AGENDA
Historic Yorktown Design Committee

SUBJECT: Application No. HYDC-281-26, Jeffrey Vance, 114 Ballard Street: Request for review of new backyard detached garage

SUBJECT: Application No. HYDC-282-26, County of York, New Stage Awning, 331 Water Street

FRONT ELEVATION

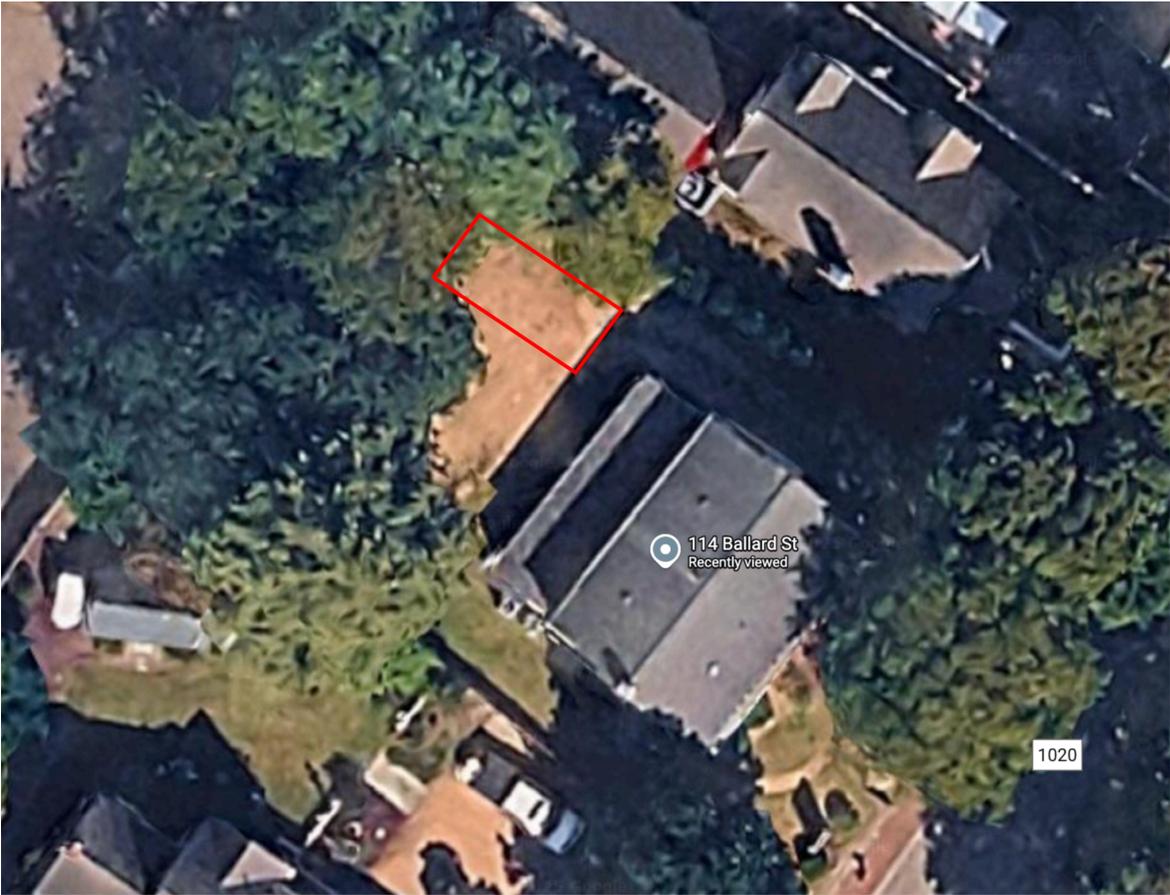
This application, submitted by Jeffrey Vance, seeks approval to establish a new detached garage in his backyard at 114 Ballard Street. According to the applicant's narrative, the detached garage would be one story (14 feet tall) and 23 feet in length by 12 feet in width (276 sq. ft.). It would have a rectangular form with a gabled roof that has a 7:12 pitch. (The applicant submitted an addendum that changed the proposed roof pitch from 10:12 to 7:12.)

This addendum is submitted on 1/23/26 to modify the application package. As such, the roof pitch of the detached garage will be 7:10 in order to be in conformance with the HYDC guidelines that the pitch of the supplemental building (detached garage) be the same or less than the pitch of the primary home.

Original requested roof pitch: 10:12

Amended roof pitch: 7:12

OPTION 1

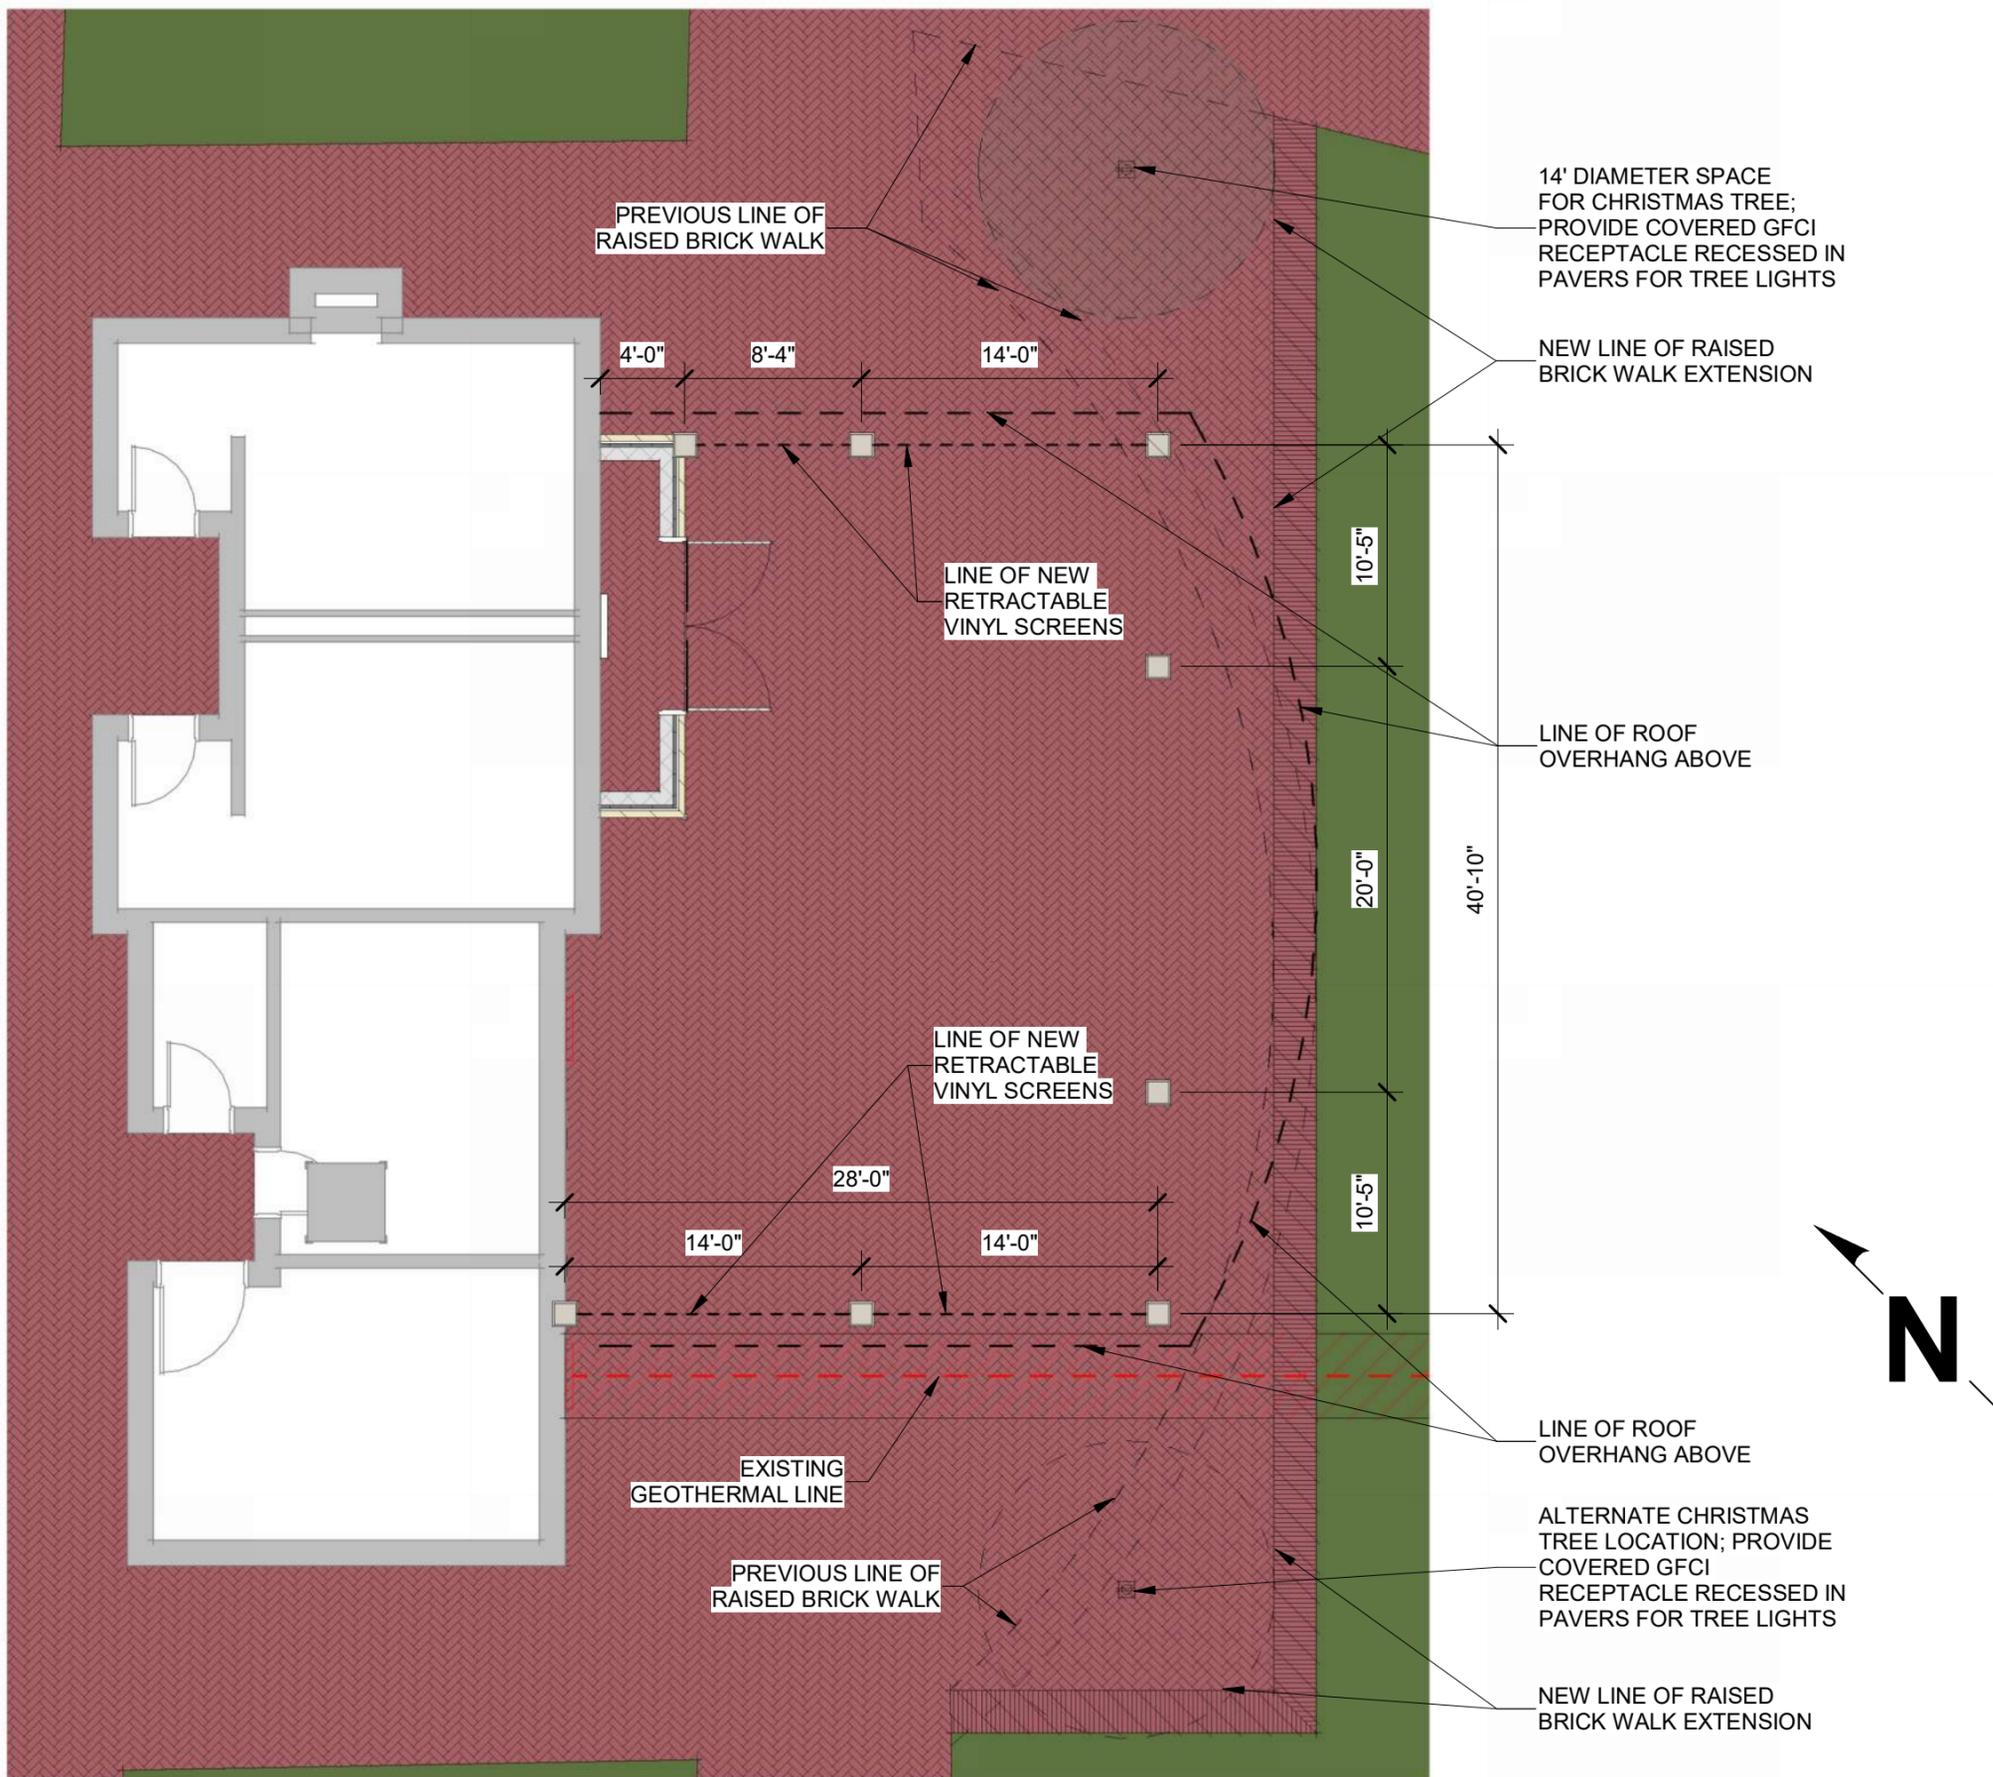
The first option would include a relatively flat roof. The applicant stated in their narrative that it would have a minimum pitch, just enough to allow rain to be shed. It would span 28' x 40', be thirteen feet (13') in height, and one side would be rounded into a curve, like a half-circle. It would have eight square posts supporting the roof. The posts would be wrapped in PVC in the color Classical White.

The roof shape of Option 1 would be flat. The roof shapes of Option 2 would have gabled roofs with slopes of 14:12 and 4:12.

A flat roof is proposed for Option 1. A condition of approval has been proposed that would require the roof to adhere to this standard.

The overall design of Option 2 would be consistent with the character of Yorktown. In staff's opinion Option 1 is not consistent with the style, shape, and massing of the buildings on Main Street.

1. The pavilion shall be constructed in accordance with the application materials submitted by the applicant and received by the Planning Division on January 8, 2026, and supplemental information submitted by the applicant and received by the Planning Division on January 26, 2026, copies of which will remain on file with the Planning Division, except as modified herein.
2. All trim, siding, posts, and columns shall be constructed of wood painted Classical White (SW2829) or Glen Gery 53DD brick.
3. Flat roofs shall not be permitted
4. Trim shall not exceed 2 inches in actual thickness, 6 inches in width at corners and 4 inches around openings.
5. Mortar shall be in a beige-to-tan color range.
6. All roof slopes shall be less than 9:12.
7. All colors shall be selected from the Yorktown Color Palette.

OPTION 2

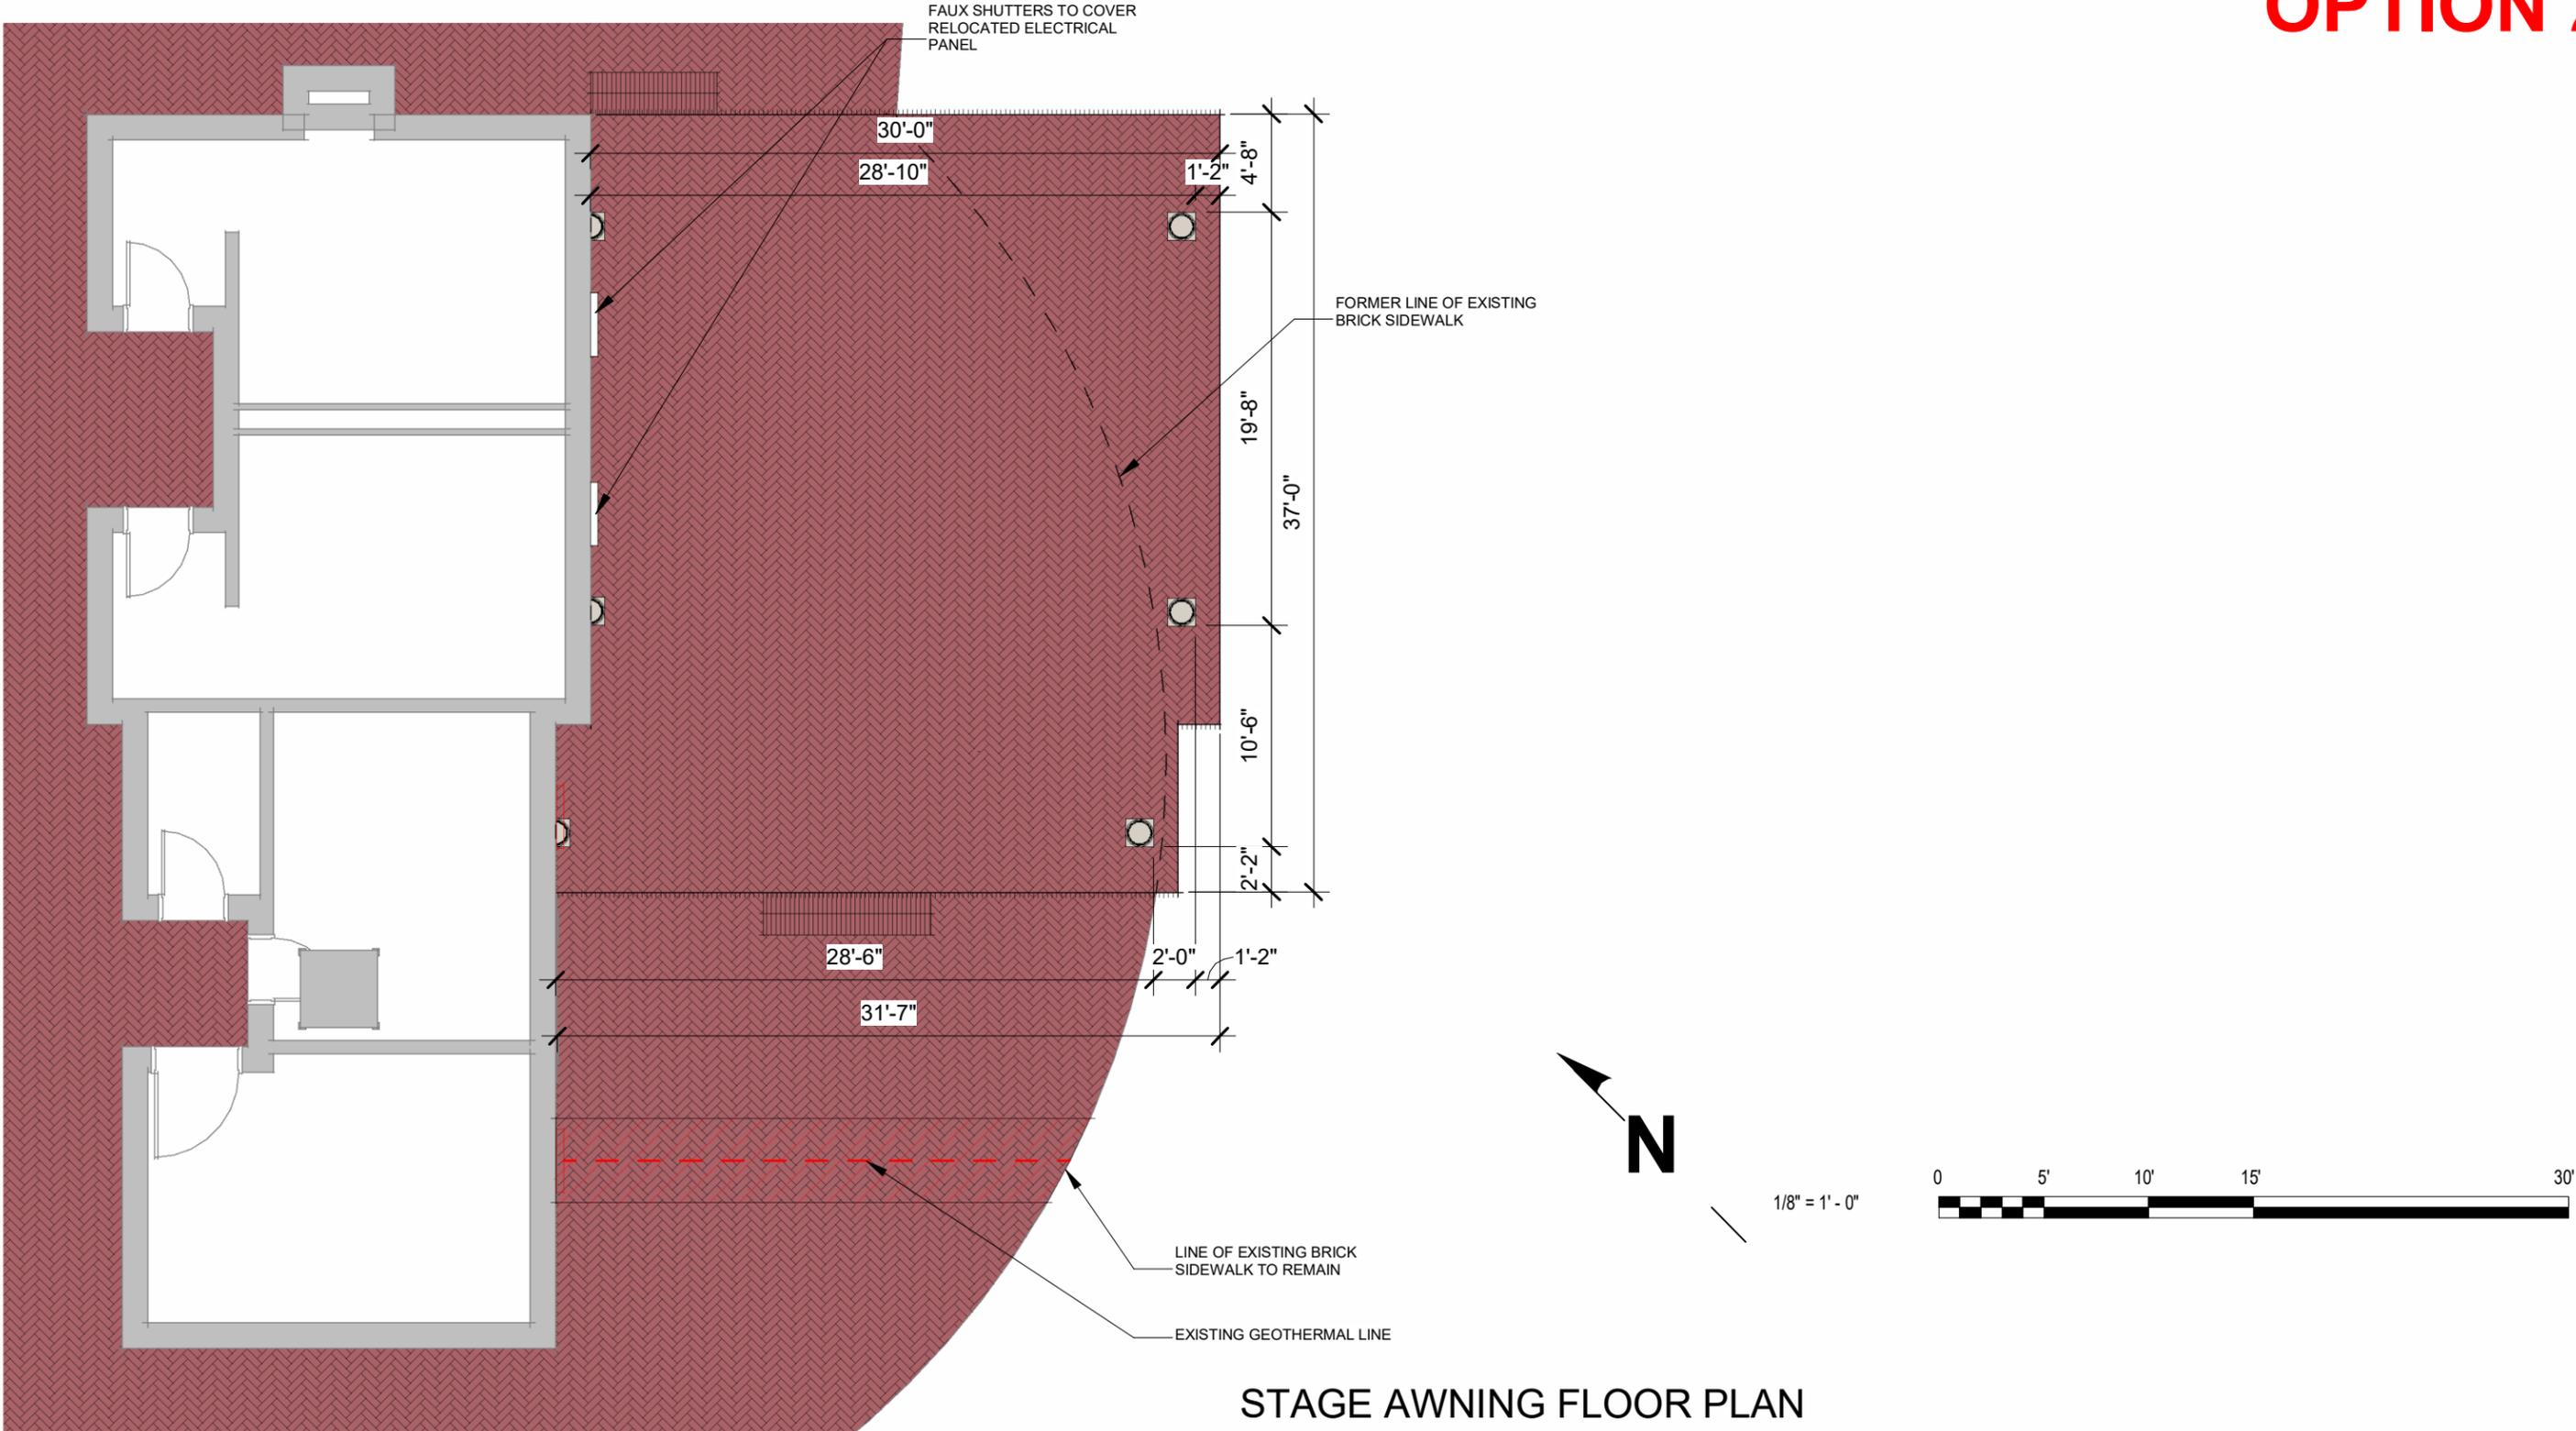
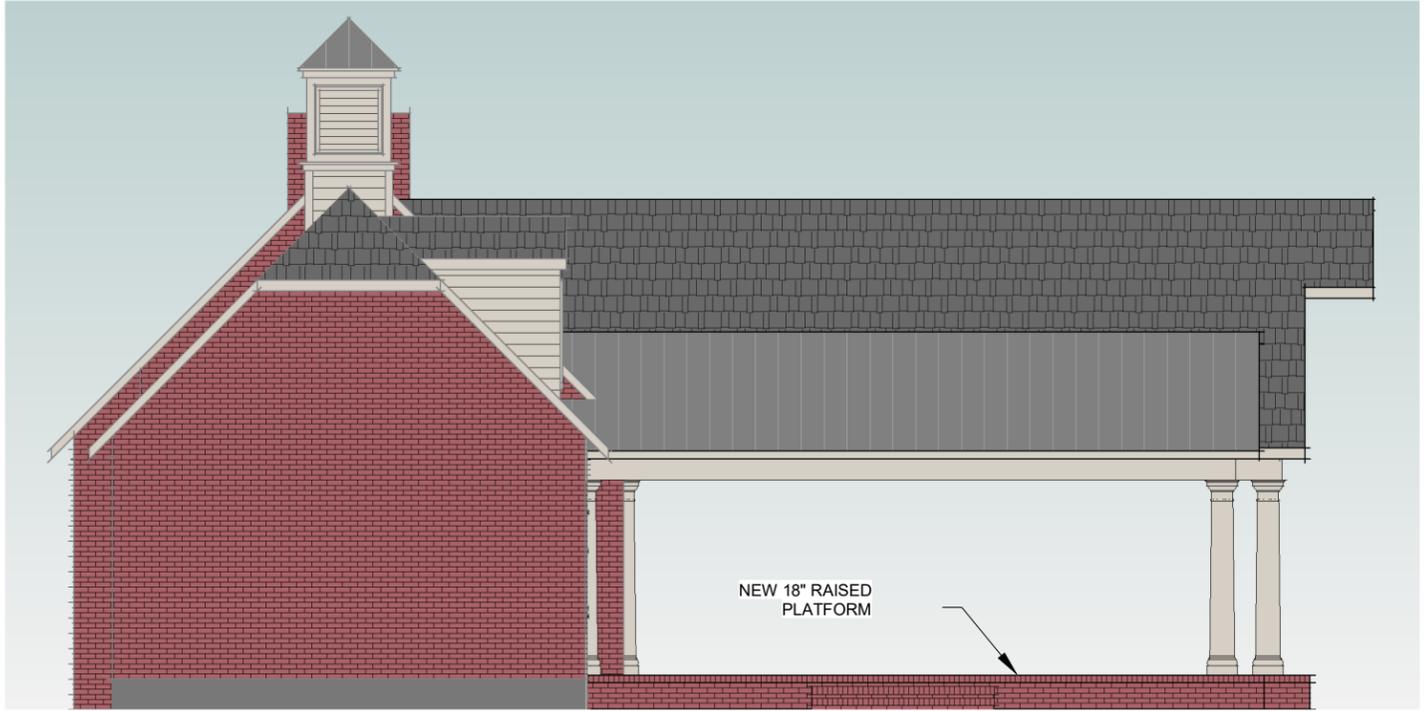
The second option would have two gable-style roofs clad with Davinci synthetic slate tiled in the color European Gray. The taller roof would have a pitch of 14:12 and the shorter one would have a pitch of 4:12. The roofs would cover an area of 37' x 30', be twenty-two feet (22') in height, and would have six cylindrical columns supporting them. The columns would be wrapped in PVC in the color Classical White. Option two would have motorized retractable vinyl screens with a black border along the north and south sides of the roof, inset with beams and columns.

Option 1 would be 13 feet in height. Option 2 would be 22 feet in height. Staff believe the height would relate to those of the existing and adjacent structures and would maintain desirable views to and from the Waterfront.

2. The rendering on Option 2 shows two different treatments on the roof tops (the 14:12 and the 4:12 roof tops). Will both be clad with Davinci synthetic slate tiles? **Yes**
